Well Name: JAMES RANCH UNIT DI 7 SAWTOOTH	Well Location: T23S / R31E / SEC 6 / LOT 3 /	County or Parish/State:
Well Number: 805H	Type of Well: OIL WELL	Allottee or Tribe Name:
Lease Number: NMNM02953C	Unit or CA Name: JAMES RANCH	Unit or CA Number: NMNM070965Z
US Well Number:	Well Status: Approved Application for Permit to Drill	Operator: XTO PERMIAN OPERATING LLC

Sundry ID: 2773928

Type of Action: APD Change

OPERATOR'S NAME:	XTO Permian Operating LLC
WELL NAME & NO.:	James Ranch Unit DI 7 Sawtooth 805H
LOCATION:	Sec 06-23S-31E-NMP
COUNTY:	Eddy County, New Mexico

WELL LOCATION AND ACREAGE DEDICATION PLAT

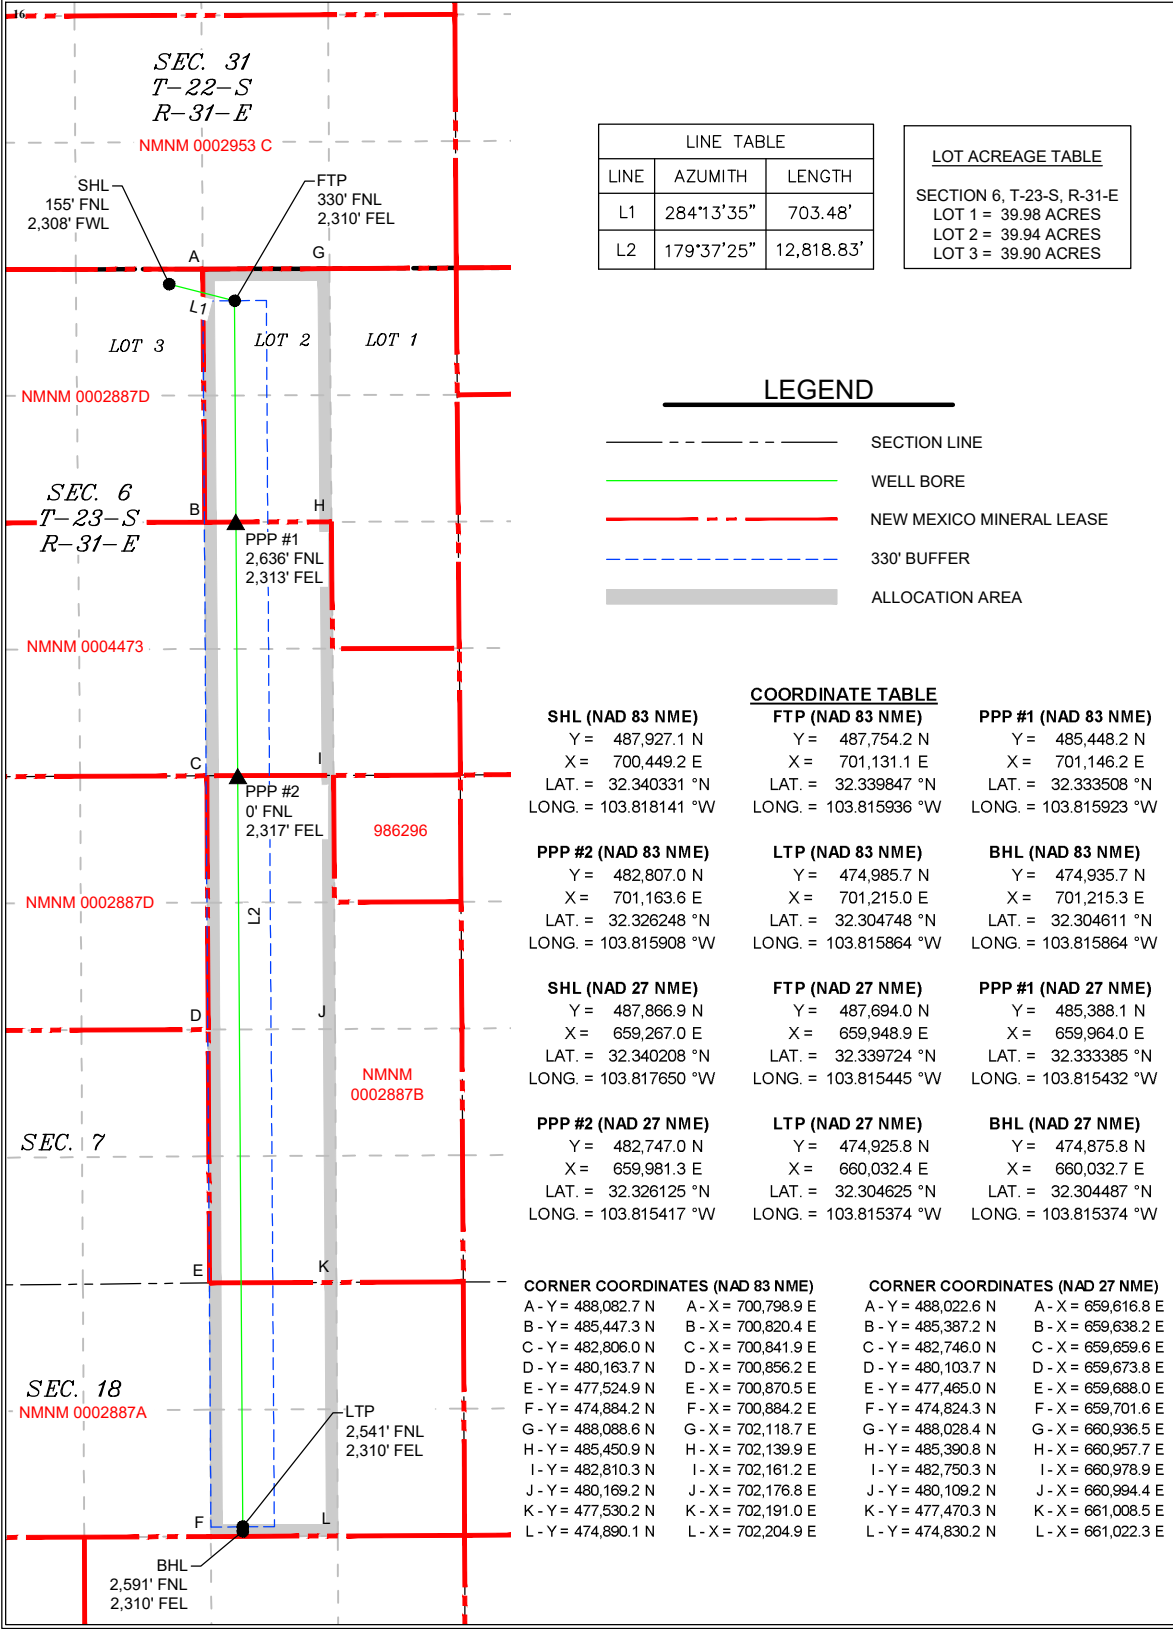
XTO Permian Operating LLC respectfully requests a change to the wellbore location that will include the following changes: Surface Hole Change, First and Last Take Point.

SHL: FROM: 155' FNL & 2338' FWL TO: 155 FNL & 2308 FWL of Section 6-T23S-R31E
FTP: FROM: 700 & FSL & 2090 FWL TO: 330 FNL & 2310 FEL of Section 6-T23S-R31E
PPP#1: 2636' FNL & 2313' FEL
PPP#2: 0' FNL & 2317' FEL
LTP: FROM: 2538 FNL & 2090 FWL TO: 2541 FNL & 2310 FEL of Section 18-T23S-R31E
BHL: FROM: 2588 FNL & 2090 FWL TO: 2591 FNL & 2310 FEL of Section 18-T23S-R31E
